Date: October 2020

Design Change of Aluminum Handle AV/AH-series Polishing

Before Change	After Change
Rim	With Buffing	No Buffing
Appearance (1 Part Number Excerpt)	AH-160 	AH-160

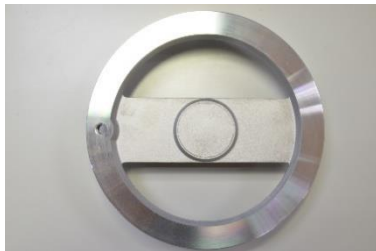
Due to manufacturing reasons, the buffing on the rim of the aluminum handle will be eliminated. Dimensions and shapes will not change due to these changes.

Although the specification will be "No Buffing", the same standard of surface roughness will be maintained as the product before the changes.
